TENNESSEE VALLEY AUTHORITY  
BROWNS FERRY NUCLEAR PLANT (BFN)  
UNITS 1, 2, AND 3

PROPOSED TECHNICAL SPECIFICATION (TS) CHANGE TS-349  
MARKED PAGES

Figure 3.6.-1  
(BFN Unit 1)

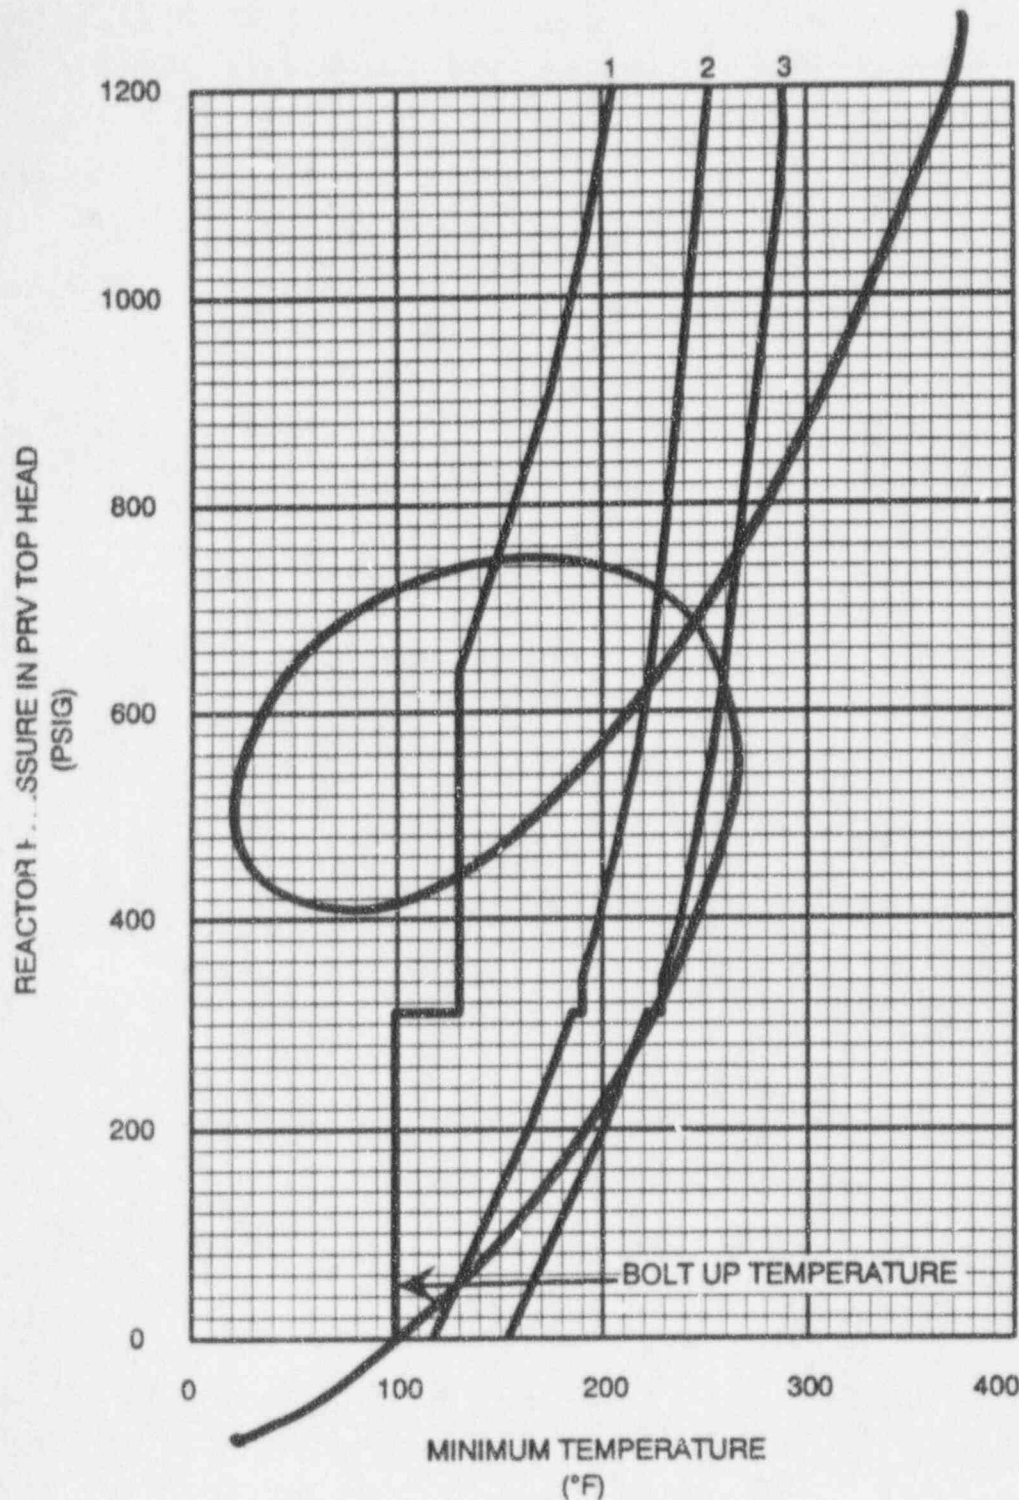
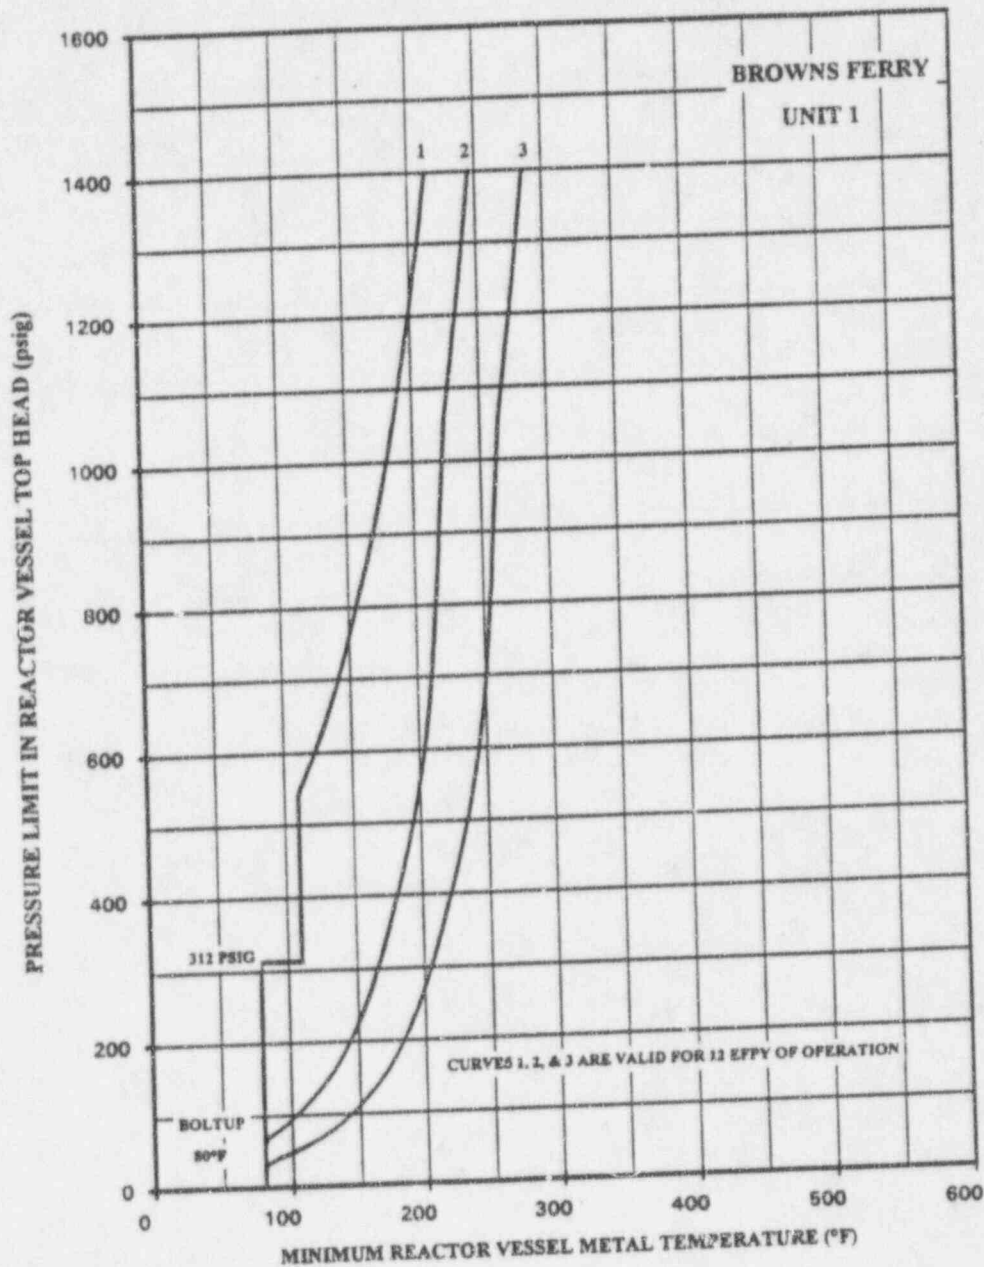
Replace with attached figure

Minimum temperature for pressure tests such as required by Section XI. Minimum temperature of 105 °F is required for test pressure of 1,100 psig.

Minimum temperature for pressure tests such as required by Section XI. Minimum temperature of 191° F is required for test pressure of 1,100 psig.

Figure 3.6-1  
(BFN Units 2 and 3)

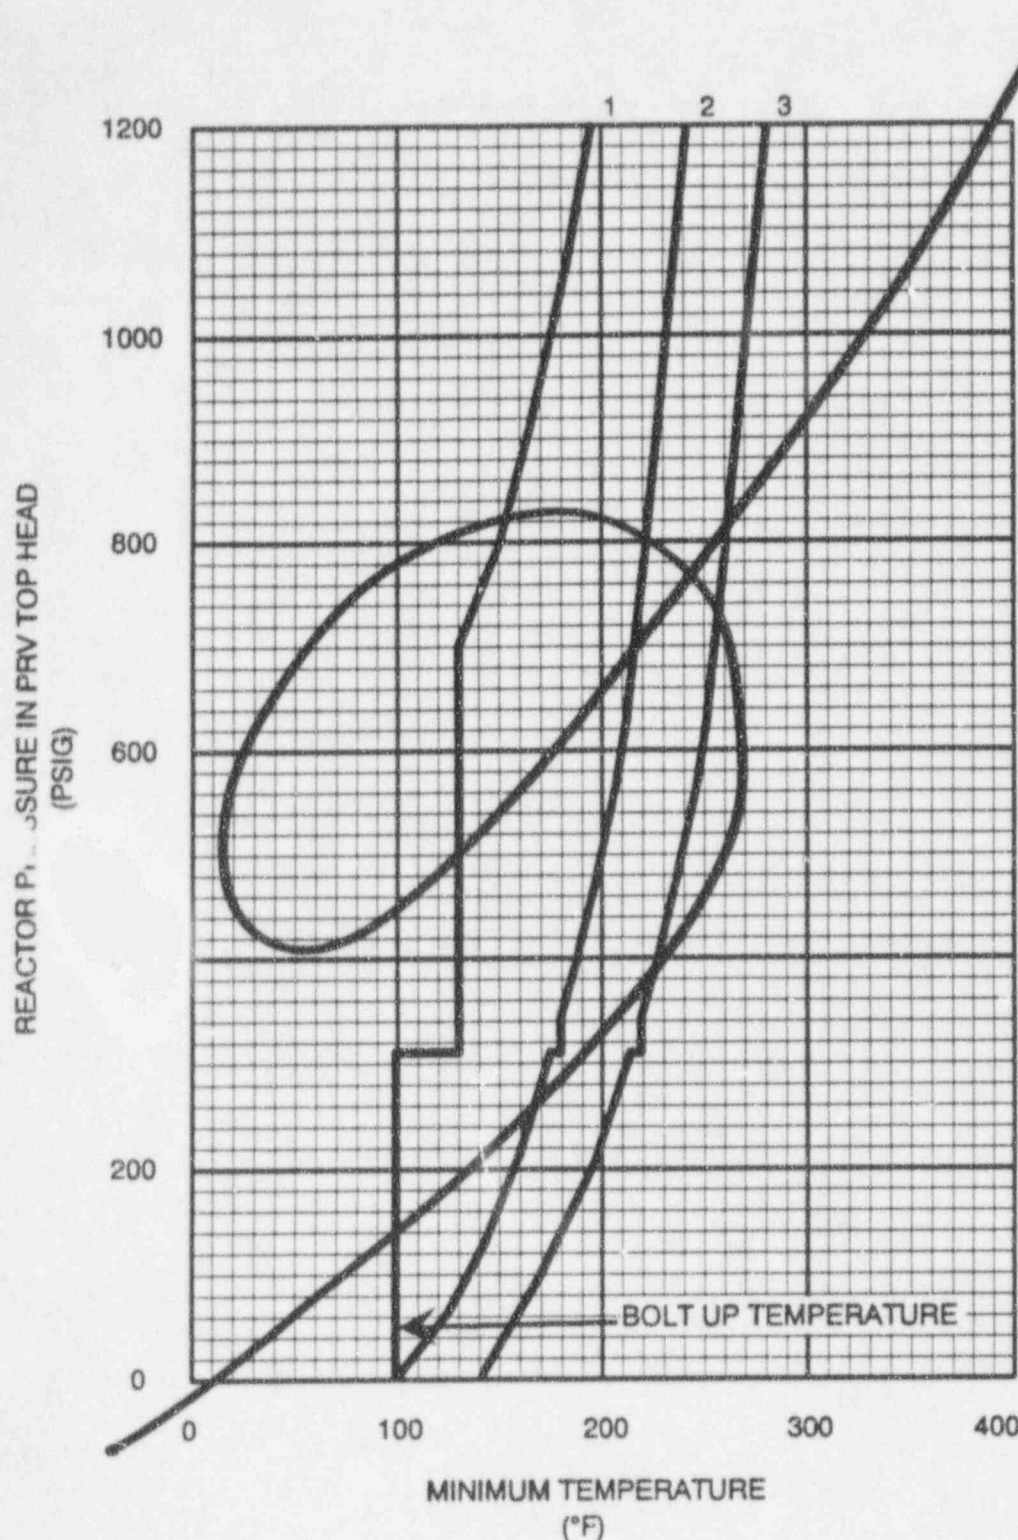
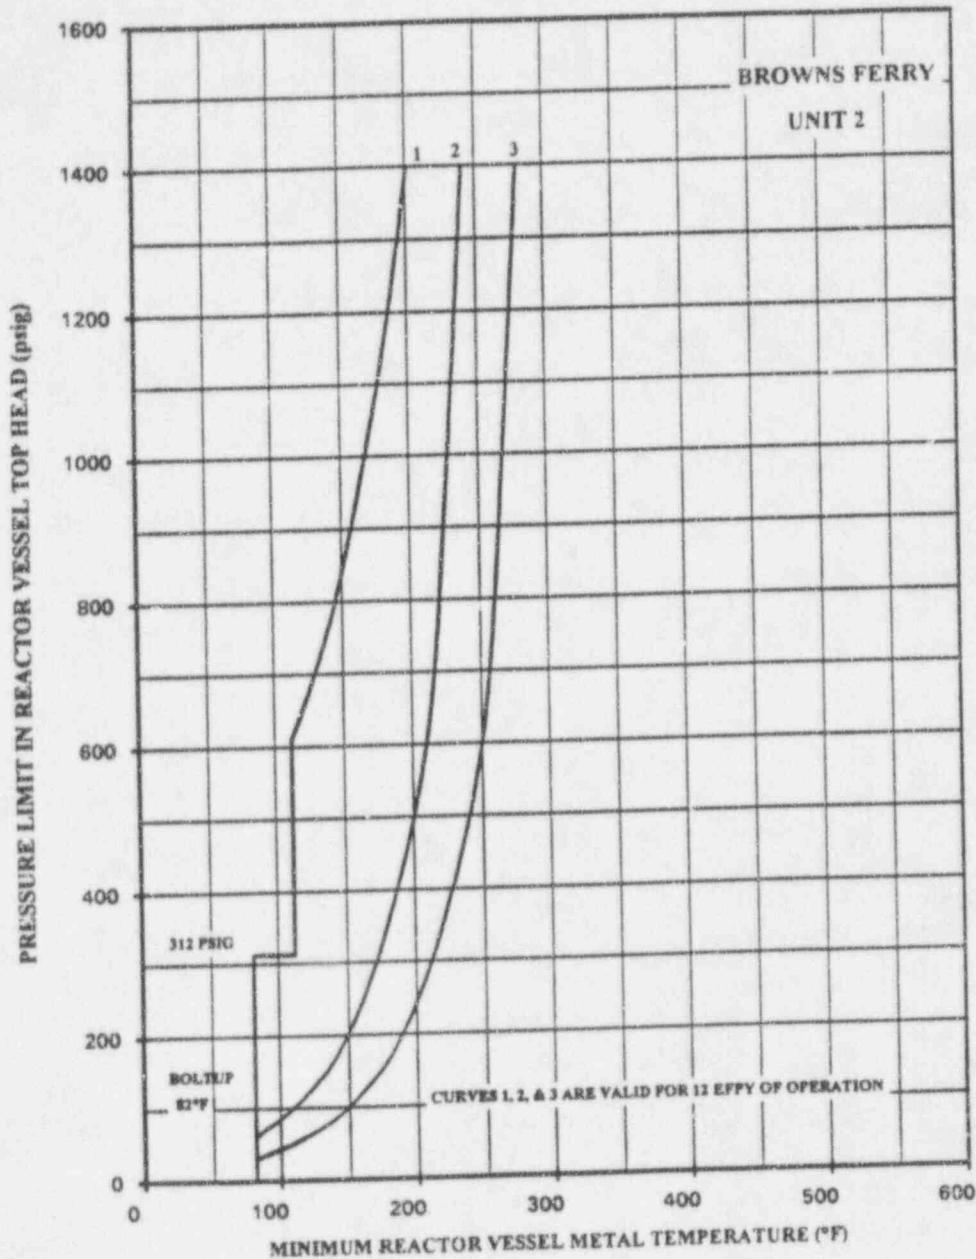
Replace with attached figure

Minimum temperature for pressure tests such as required by Section XI. Minimum temperature of 178 185°F is required for test pressure of 1,100 psig.

Minimum temperature for pressure tests such as required by Section XI. Minimum temperature of 178°F is required for test pressure of 1,100 psig.

Figure 3.6.-1  
(BFN Units 2 and 3)

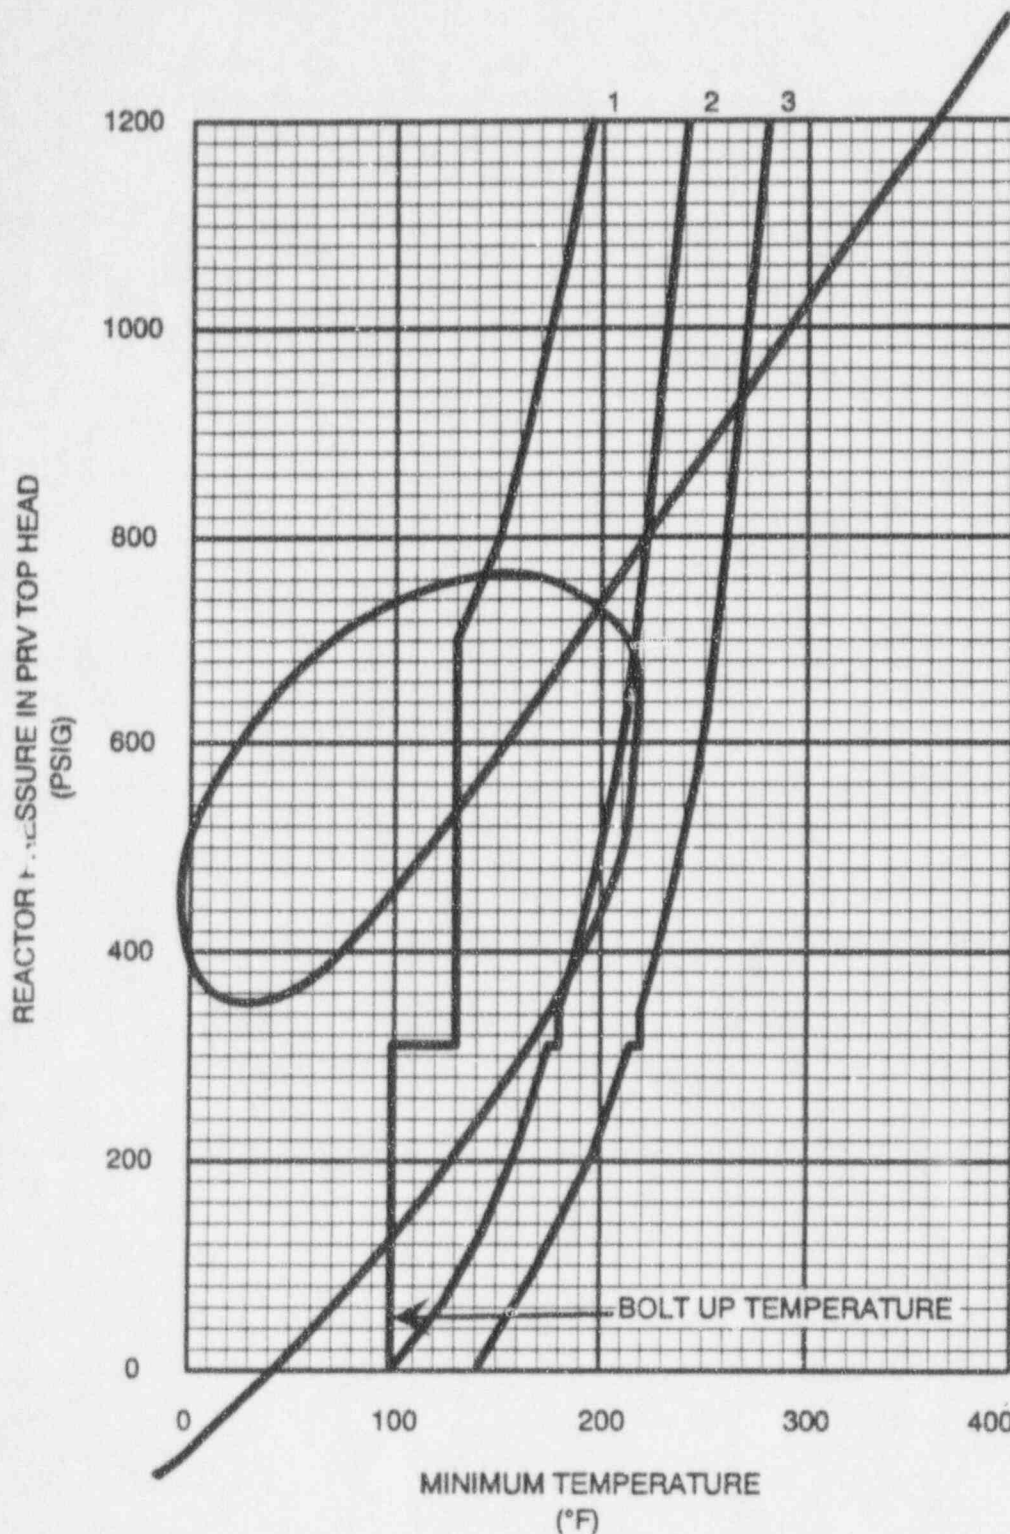
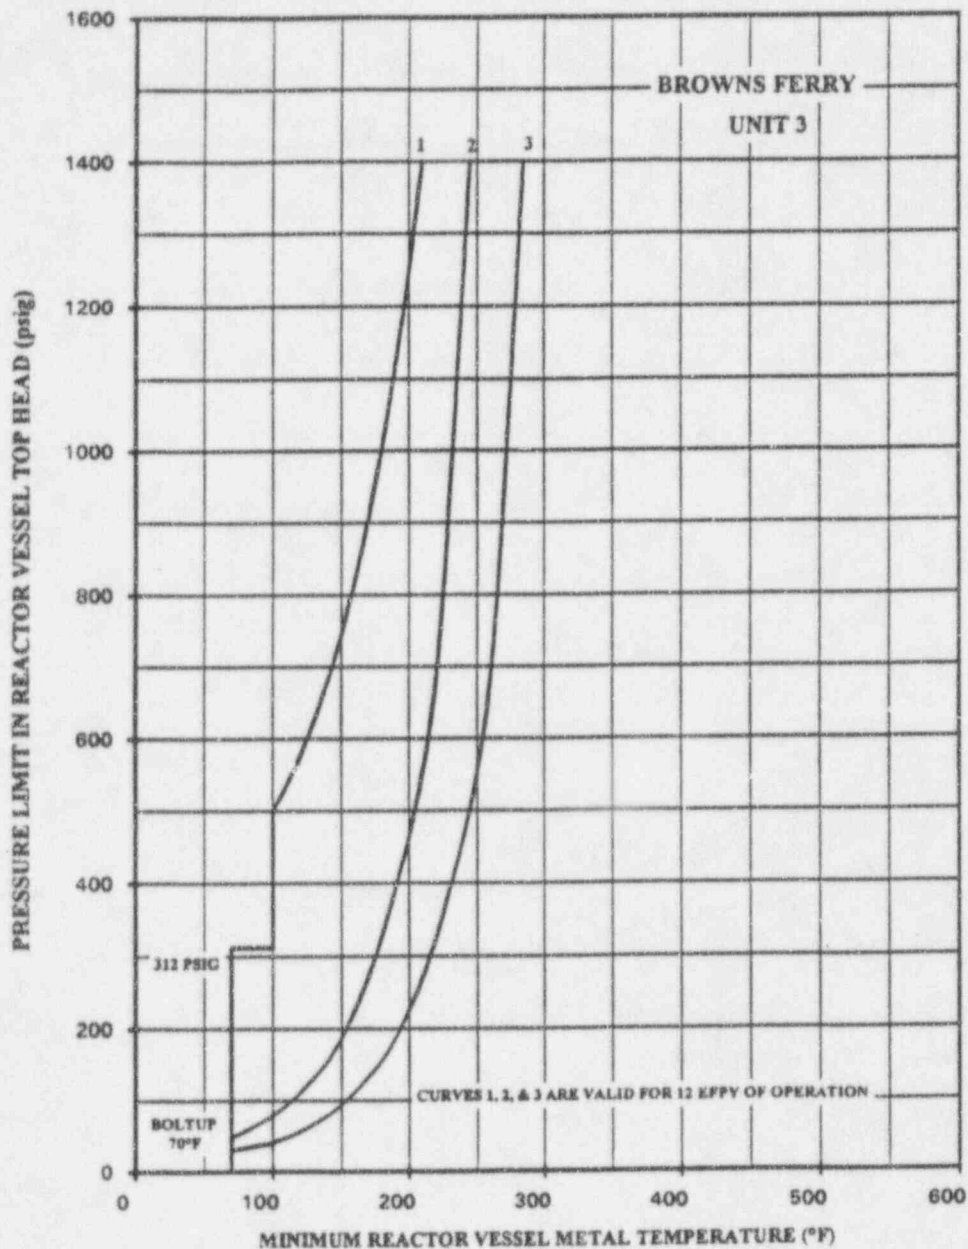
*Replace with attached figure*

Curve No. 1  
Minimum temperature for pressure tests such as required by Section XI. Minimum temperature of 189 185 °F is required for test pressure of 1,100 psig.

Minimum temperature for pressure tests such as required by Section XI. Minimum temperature of 189° F is required for test pressure of 1,100 psig.
